SR 7 Route Development Plan (Phase 1)

Stakeholder Committee Meeting Summary

Meeting Date: September 29, 2005

Milepost 12.6

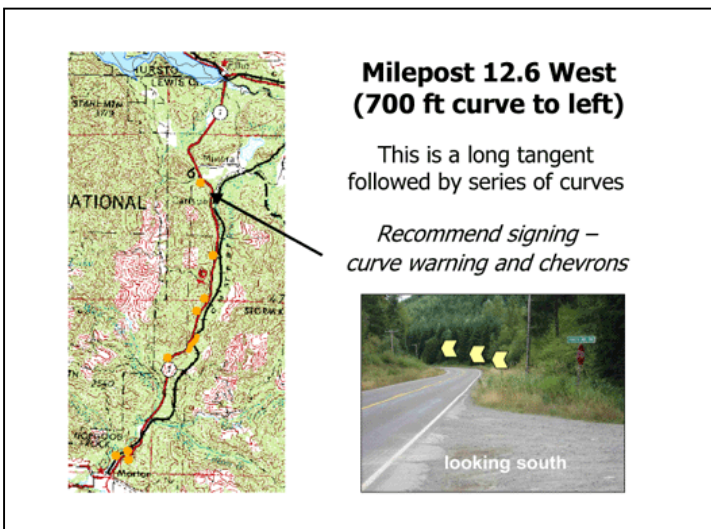
- WSDOT’s Bridge Office could review bridge condition at milepost 3.32 (Vicki/State Patrol)
- Milepost 12.6 needs more improvements. There are several accidents at this location due to snow, ice and speed. (Maintenance)

- TPA Projects – signing at milepost 12.6 will be included in the recommendations of the RDP.
